August 3, 2023

RE: Landslide Repair Project BEL-147-24.65/25.88, PID 118147  
BEL-147-25.88 - Proposed Drilled Shaft Wall Design

## Wall limits and connection

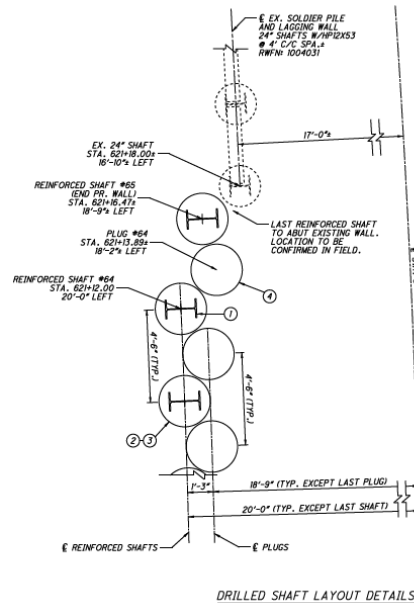
The end of the wall where we're butting up to the existing soldier pile wall will control the shaft locations. Here's an example of a plug pile wall that was installed adjacent to a soldier pile and lagging wall for your reference:
